CONTRACT CHANGE ORDER

CCO: 27 Suppl. No. 0 Contract No. 04 – 0120F4 Road SF-80-13.2/13.9 **FED. AID LOC.:**

This change order modifies the bearing blocks and provides a larger and re-located access opening for placing bearing blocks, tendon anchors, and pre-stressing jacks (used during the installation of the continuity tendons from W2 to the OBG) as shown on sheets three (3) through eighteen (18) of this change order.

SAN FRANCISCO OAKLAND BAY BRIDGE
EAST SPAN SEISMIC SAFETY PROJECT
SELF-ANCHORED SUSPENSION BRIDGE
(SUPERSTRUCTURE & TOWER)

W2 CAP BEAM POST-TENSION DETAILS NO. 5

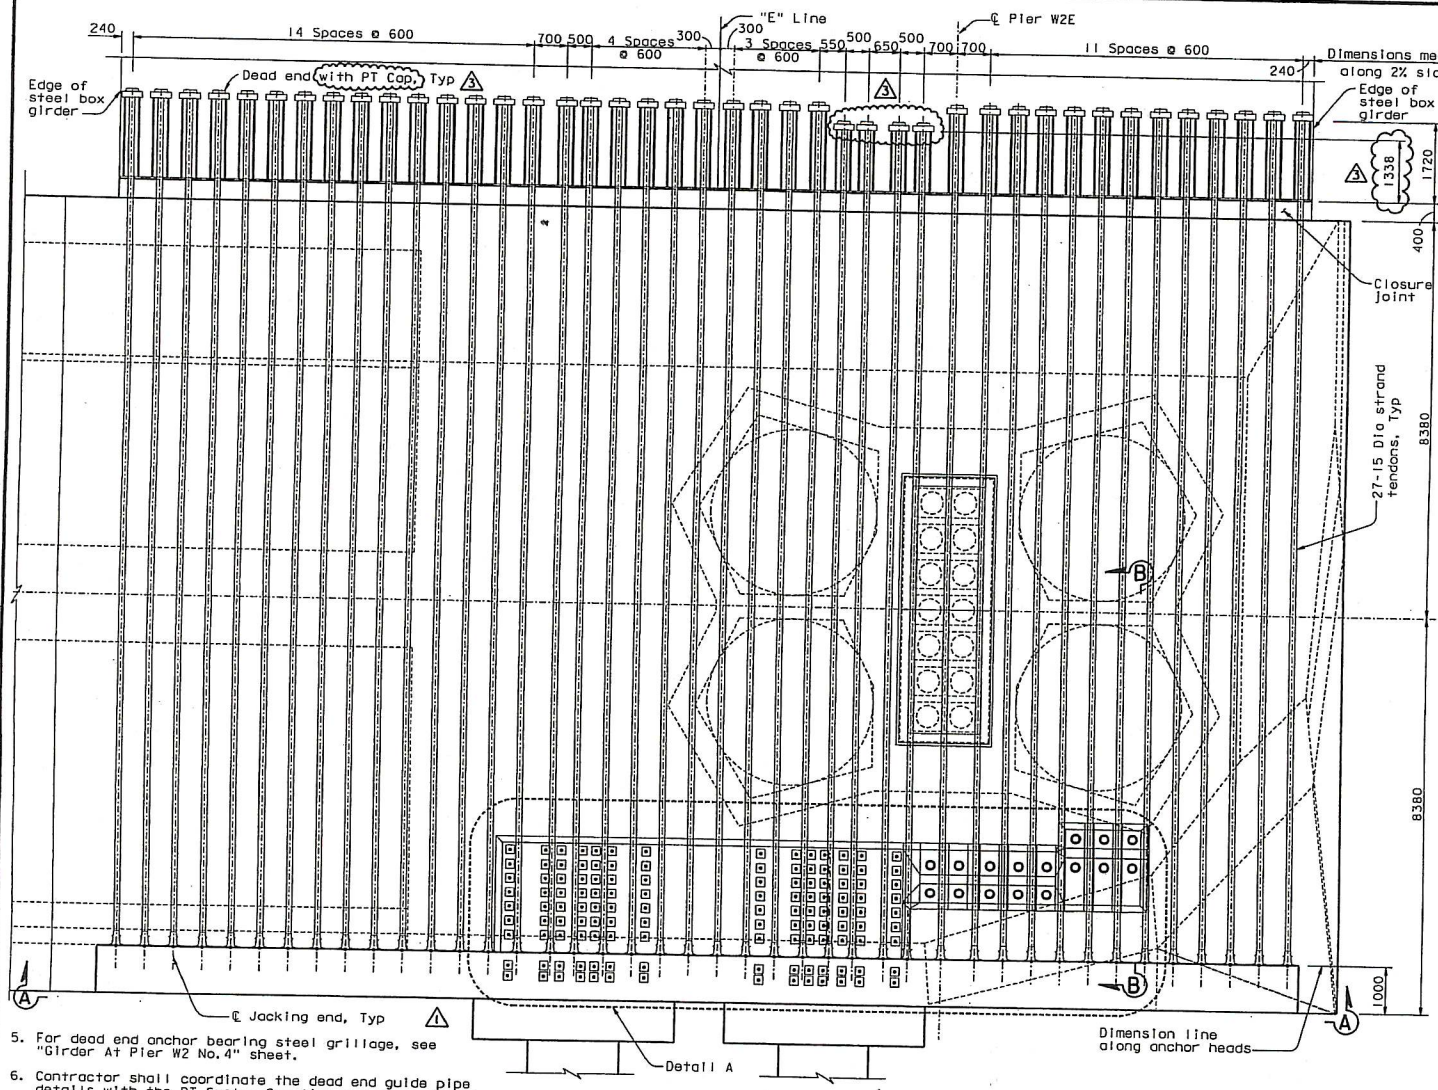
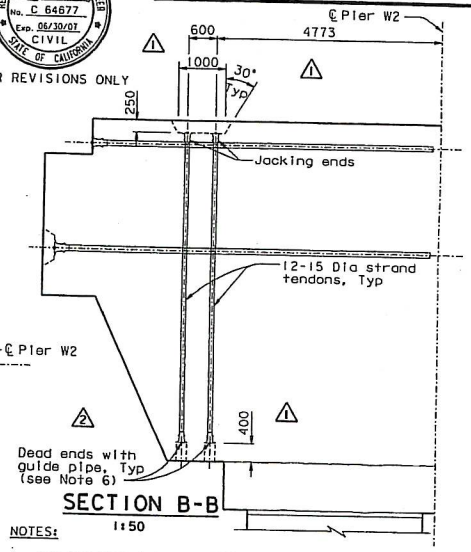
MARK	DATE	DESCRIPTIONS	BY	CH'D	CCO#
3	02/16/07	BULKHEAD AT GIRDER PIER W2	JD	AS	27
2	01/31/07	CORROSION PROTECTION	JD	AS	16
1	07/21/06	W2 CAP BEAM ISD	JD	NV	23

W2 CAP BEAM POST-TENSION DETAILS NO. 6

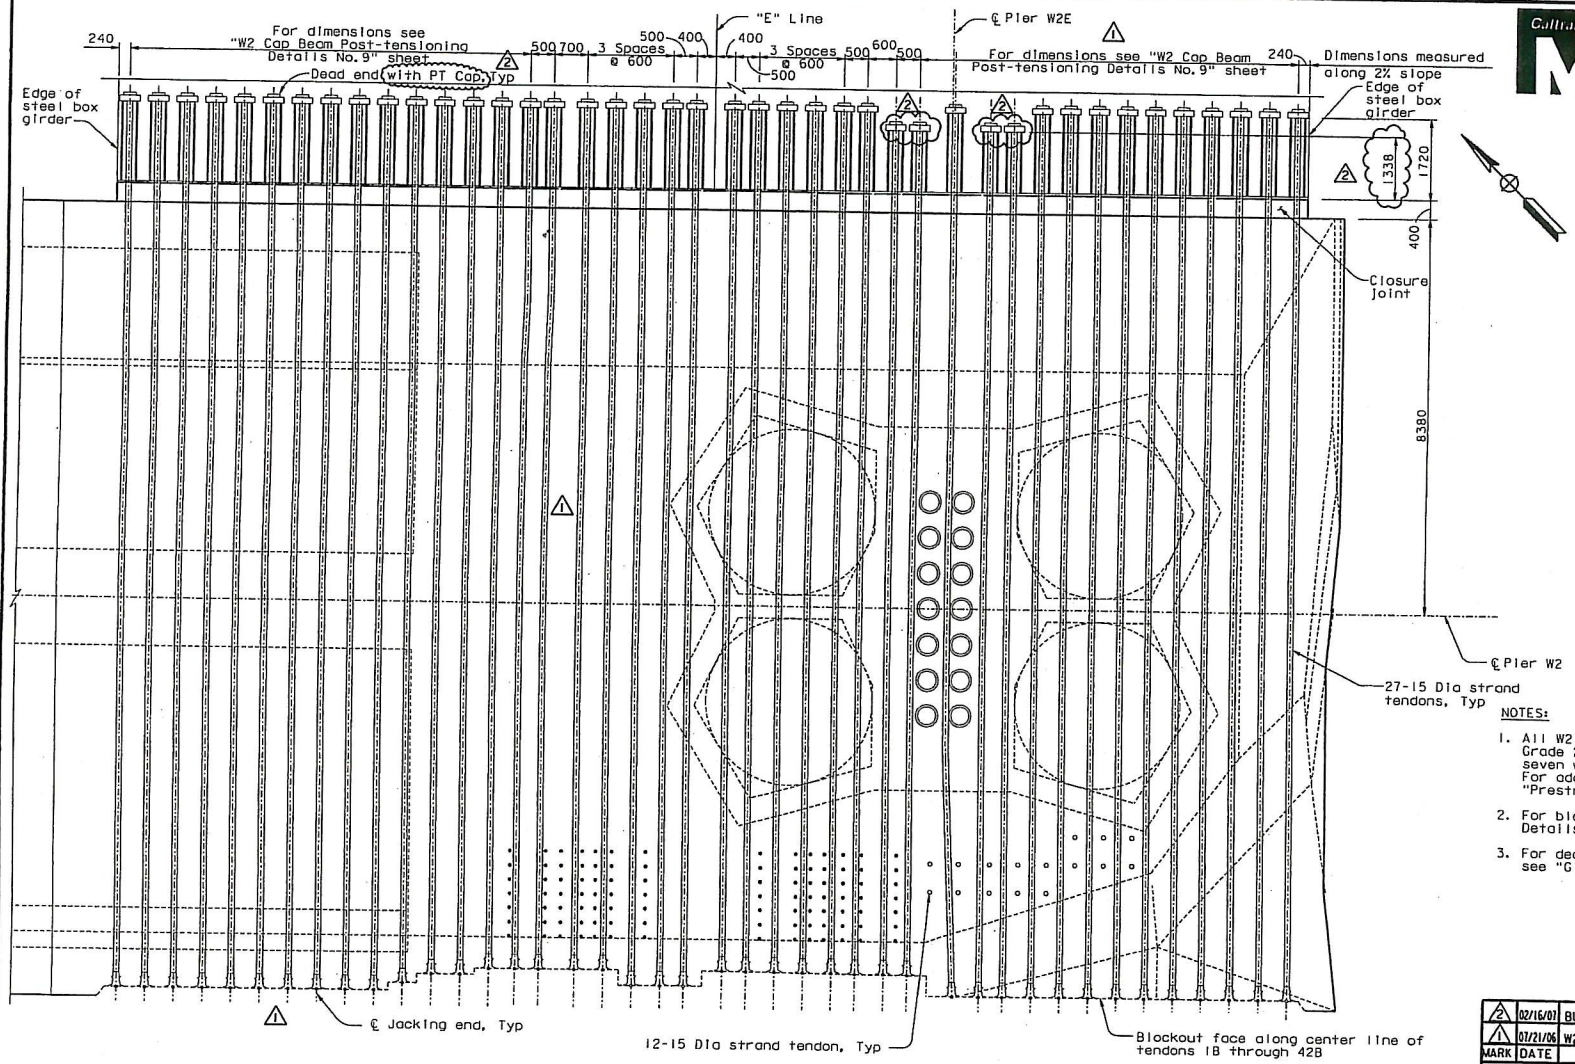
MARK	DATE	DESCRIPTIONS	BY	CH'D	CCO#
2	02/16/07	BULKHEAD AT GIRDER PIER W2	JD	AS	27
1	07/21/06	W2 CAP BEAM ISD	JD	NV	23

W2 CAP BEAM POST-TENSION' DETAILS NO. 7

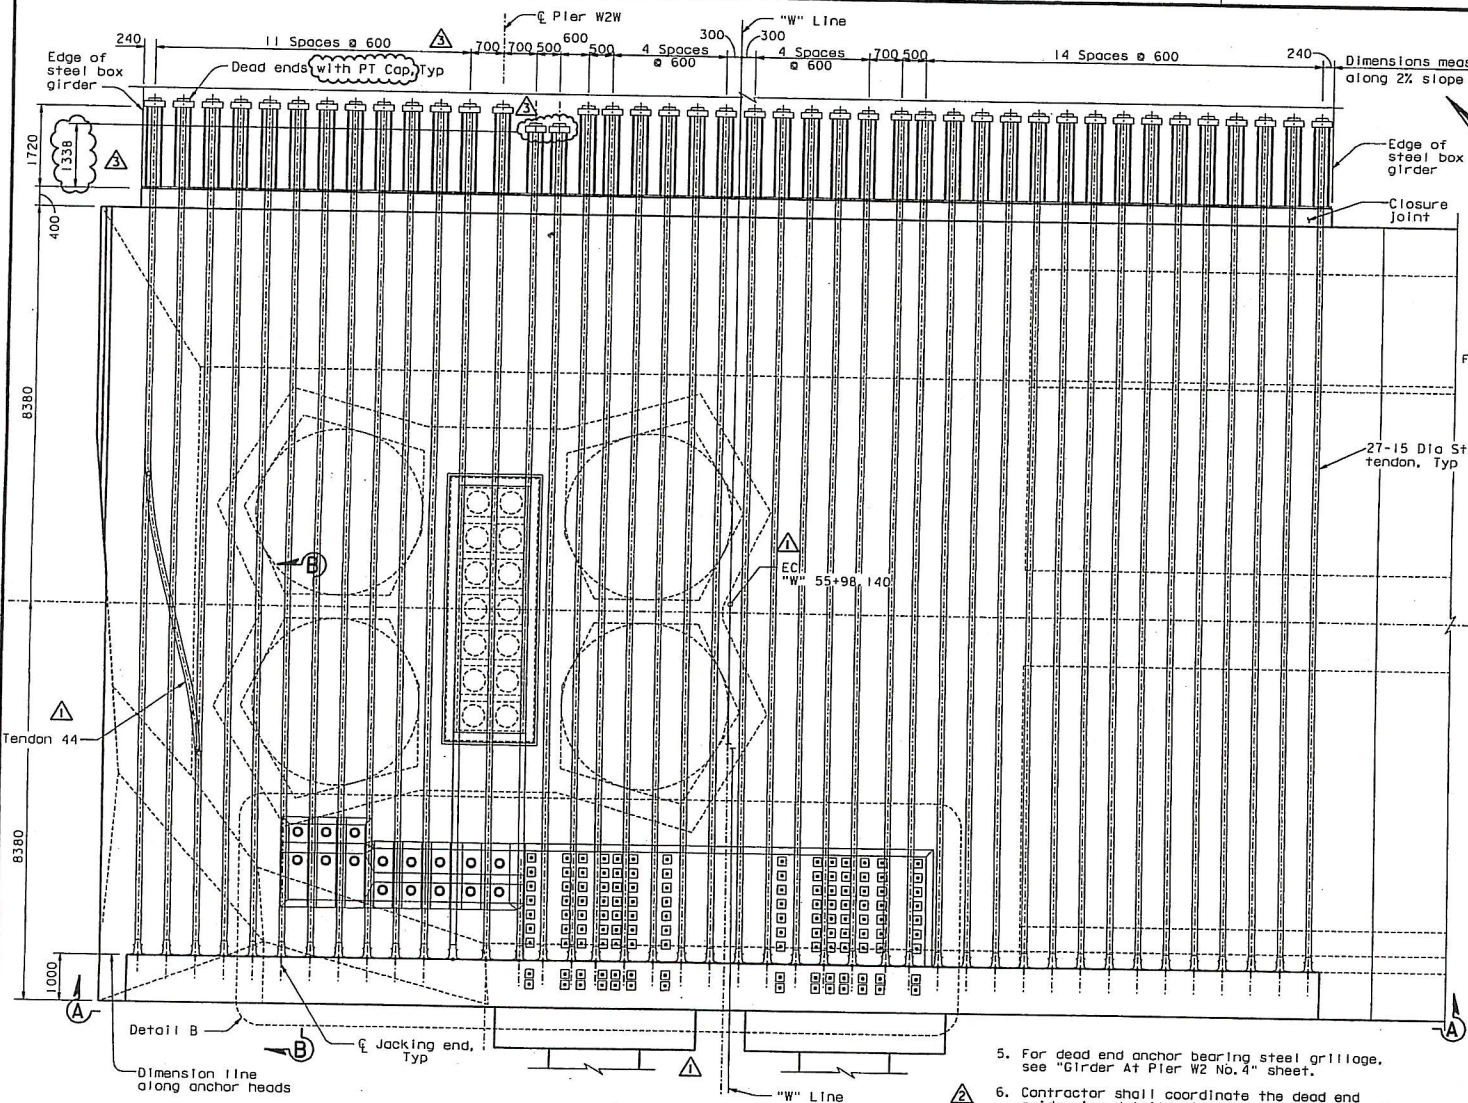
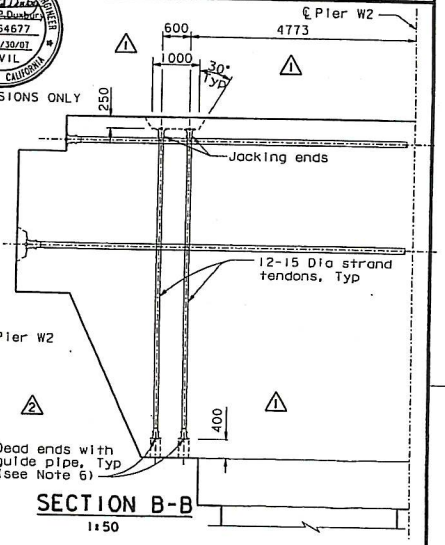
MARK	DATE	DESCRIPTIONS	BY	CH'D	CCO#
3	02/16/07	BULKHEAD AT GIRDER PIER W2	JD	AS	27
2	01/31/07	CORROSION PROTECTION	JD	AS	16
1	07/21/06	W2 CAP BEAM ISD	JD	NV	23

W2 CAP BEAM POST-TENSION DETAILS NO. 8

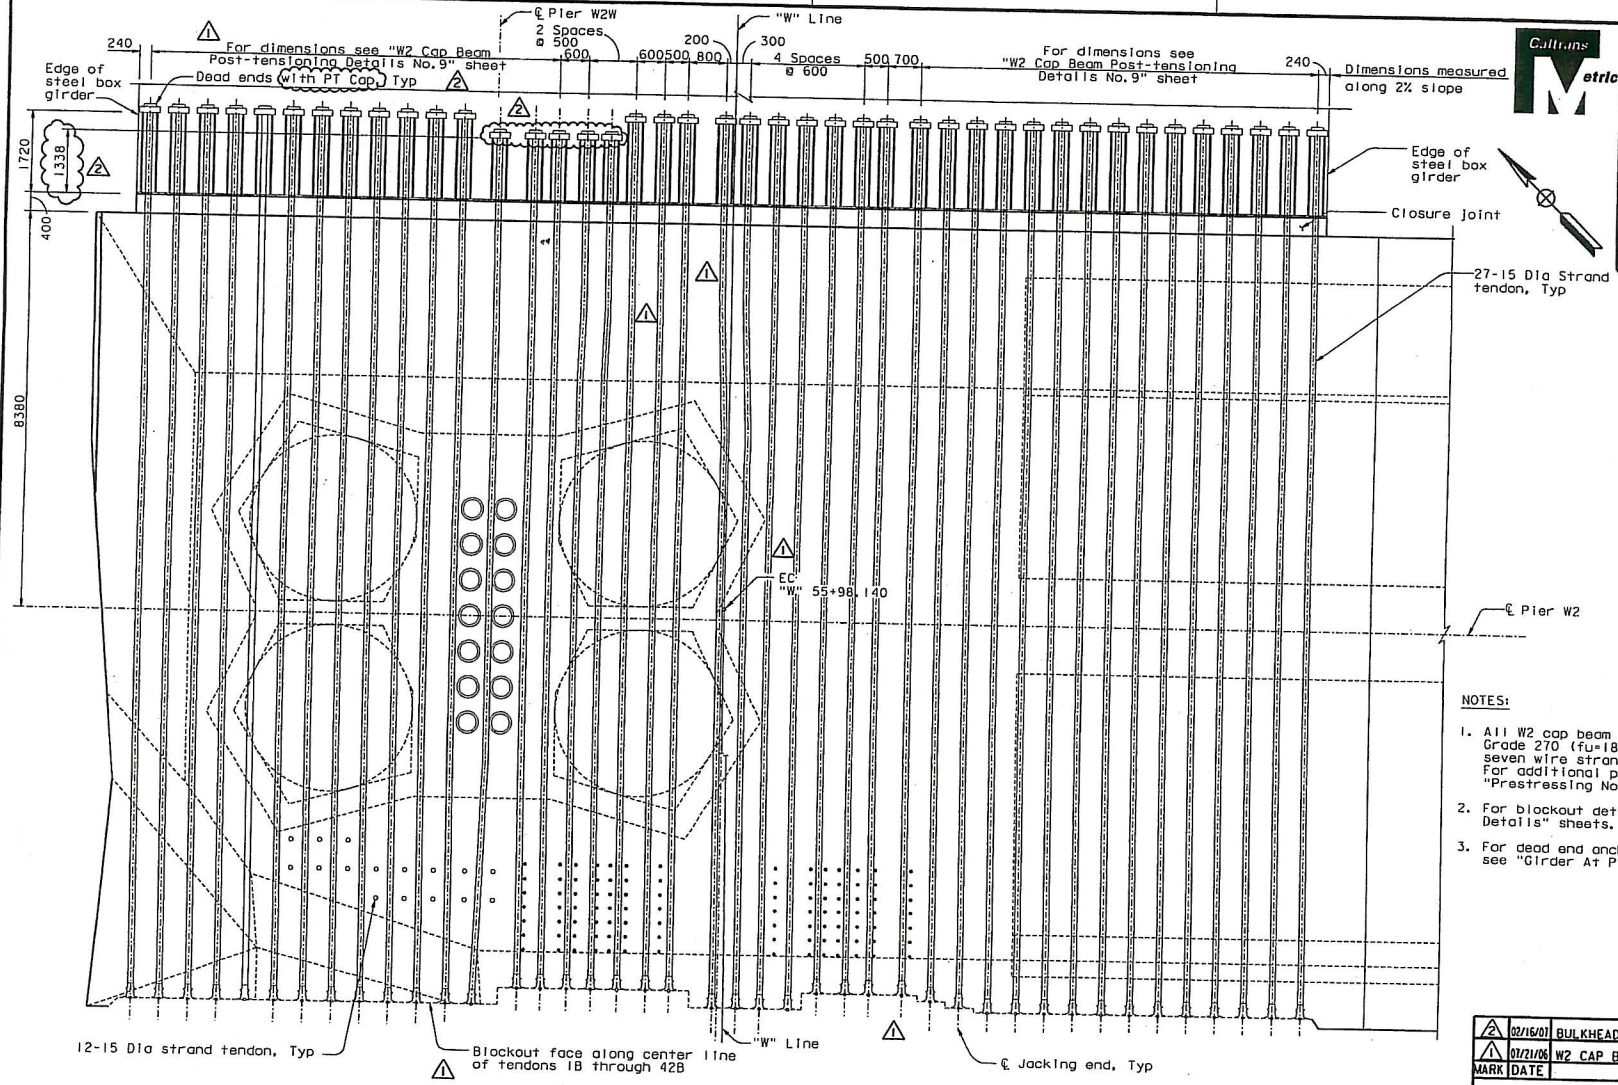
MARK	DATE	DESCRIPTIONS	BY	CH'D	CCO#
2	02/16/07	BULKHEAD AT GIRDER PIER W2	JD	AS	27
1	07/21/06	W2 CAP BEAM ISD	JD	NV	23

W2 CAP BEAM POST-TENSIONI DETAILS NO. 11

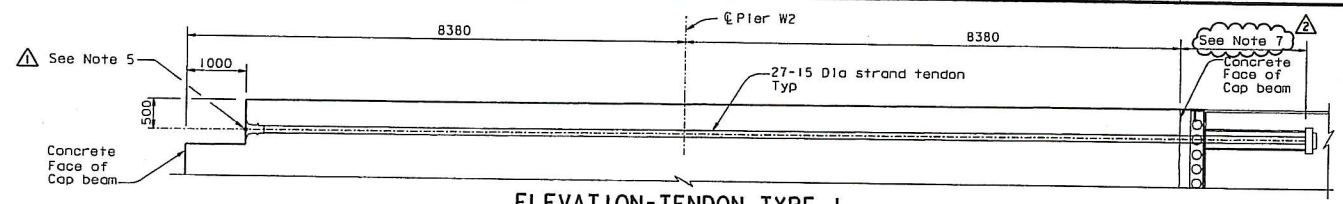
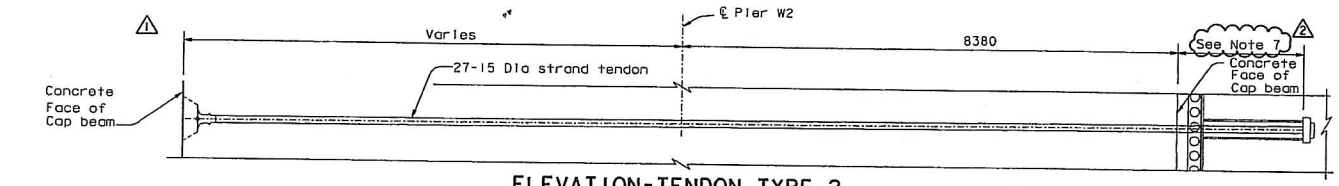
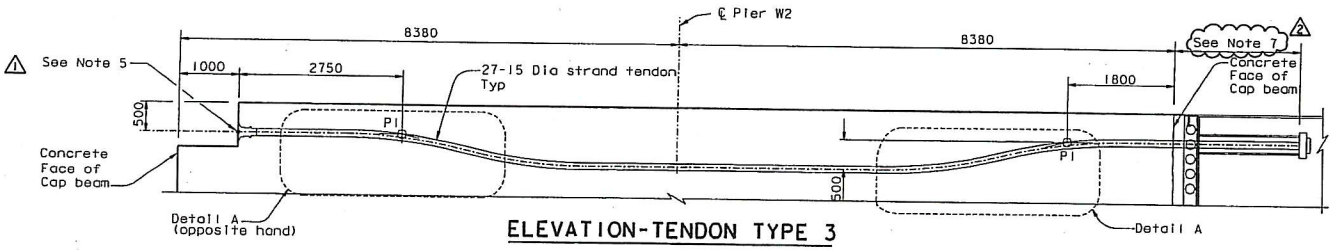
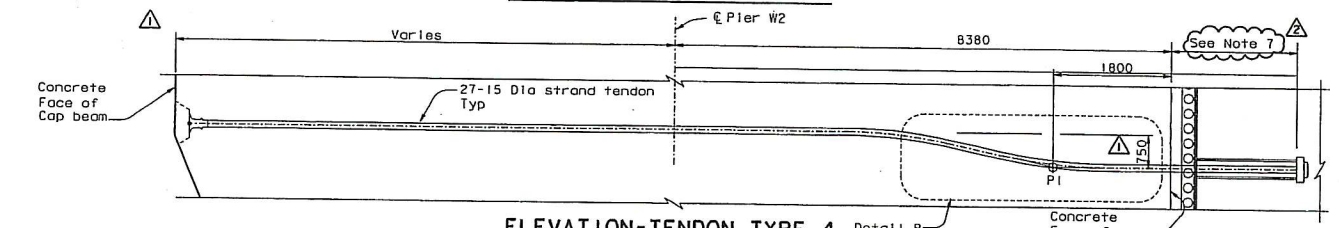
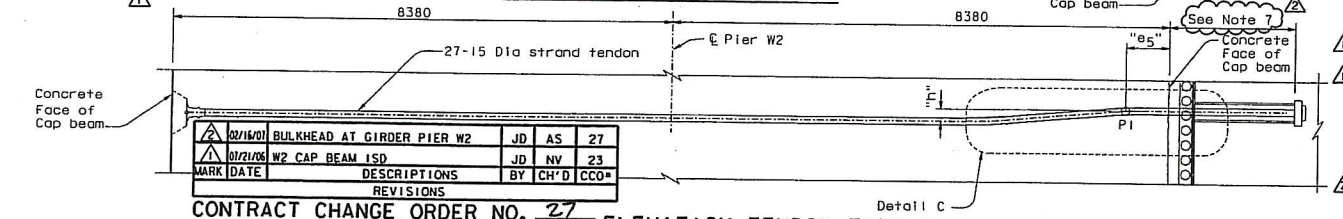
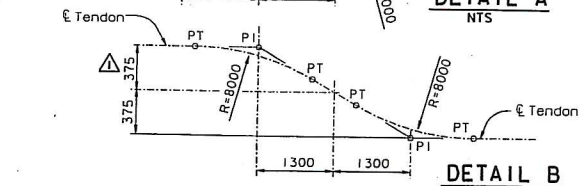
MARK	DATE	DESCRIPTIONS	BY	CH'D	CCO#
2	02/16/07	BULKHEAD AT GIRDER PIER W2	JD	AS	27
1	01/21/06	W2 CAP BEAM ISD	JD	NV	23

W2 CAP BEAM REINFORCEMENT DETAILS NO. 49

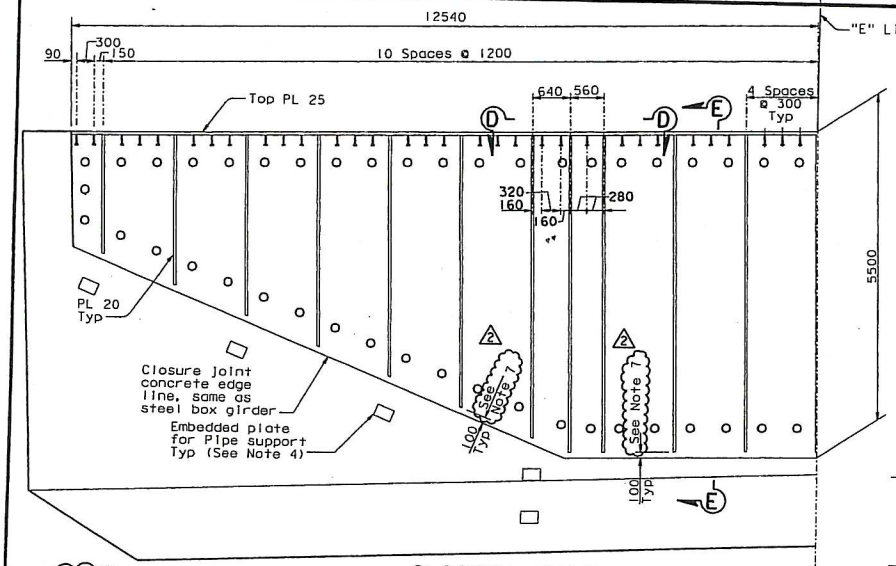
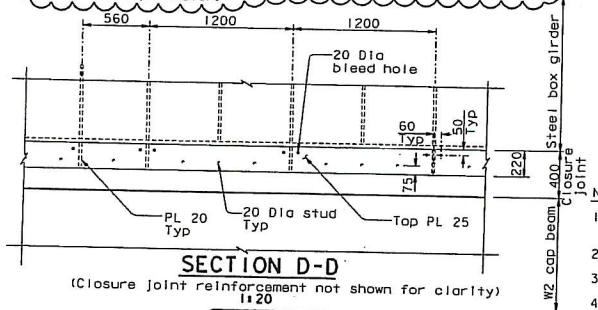
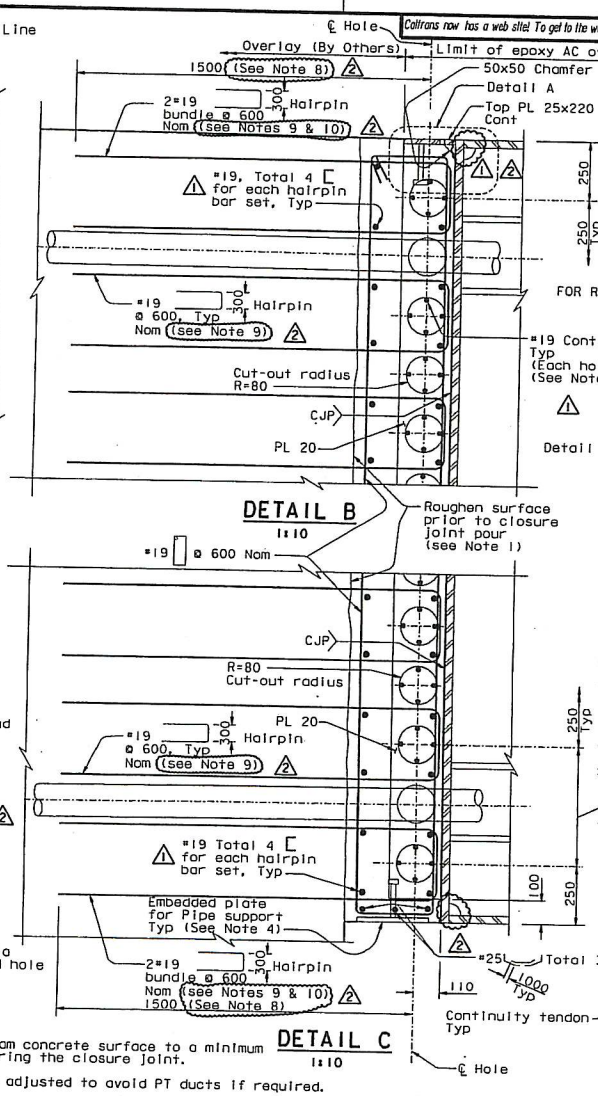
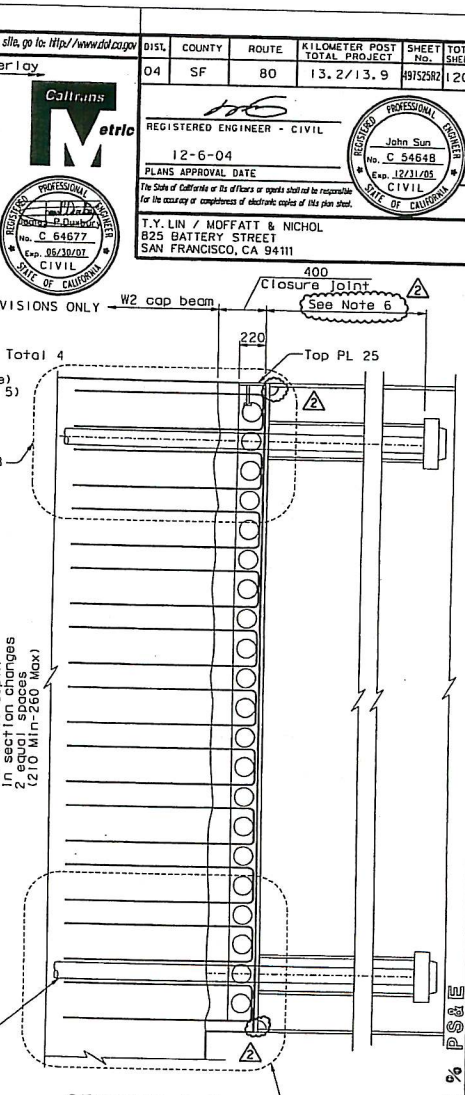
MARK	DATE	DESCRIPTIONS	BY	CH'D	CCO#
2	02/16/07	BULKHEAD AT GIRDER PIER W2	JD	AS	27
1	01/31/07	WEST DEVIATION SADDLE GEOMETRY	JD	AS	15
0	07/21/06	GENERAL REVISIONS	JD	AS	23
